GROUP	MODEL
Safety Recall Campaign	2010-2013MY Forte & Forte Koup (TD)
NUMBER	DATE
SC284TD	June 2024

### HECU MULTI FUSE REPLACEMENT (SC284TD)

This bulletin provides information to replace the multi fuse and ABS1 fuse of the Hydraulic Electronic Control Unit (HECU) and install an updated junction box label on certain 2010-2013MY Forte & Forte Koup (TD) vehicles produced from May 6, 2010 through March 22, 2013. An engine compartment fire may occur in the area where the HECU is located. The HECU may experience an internal electrical short circuit condition that can result in overcurrent, thereby increasing the risk of an engine compartment fire while the vehicle is driven or while parked. Dealers are to install new fuses to prevent an electrical short circuit condition in the HECU's electrical circuit board. Customers may experience illumination of the Malfunction Indicator Lamp (MIL), ABS warning light, burning/melting smell, and/or smoke from the engine compartment. Follow the procedure outlined in this publication to install a new multi fuse, ABS1 fuse and junction box cover label on the applicable vehicle. Before conducting the procedure, verify that the vehicle is included in

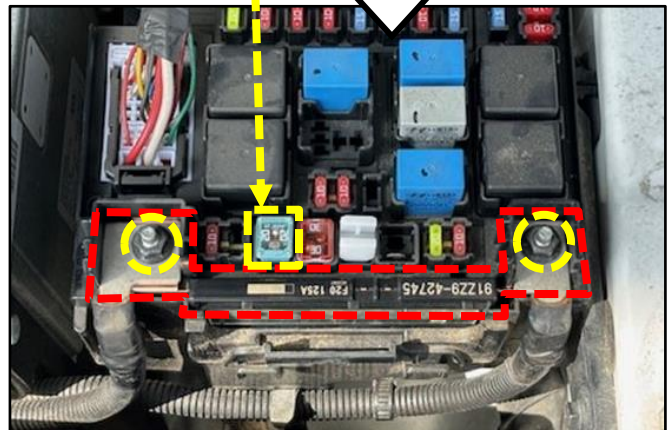
- 4a. Locate the Multi Fuse (A) for ABS2 and loosen the two (2) 10mm Multi Fuse retaining nuts (B) and remove the Multi Fuse.

- 4b. Install the **new** Multi Fuse (A) and tighten the retaining nuts (B).

- 5a. Remove the existing HECU ABS1 30A fuse (C).

- 5b. Install new amperage fuse:

- ABS1 fuse (C) → new 20A

Tightening torque for retaining nuts (B):  
7.2 - 8.7 lb.ft (9.8 - 11.8 N.m)

**Note:** Drill a hole through the center of the removed Multi Fuse. DO NOT reuse.

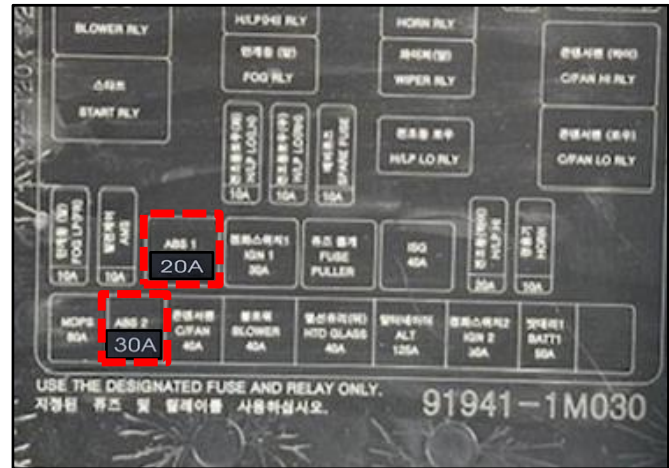
- Adhere the new fuse labels to the bottom of the junction box fuse cover, as shown.
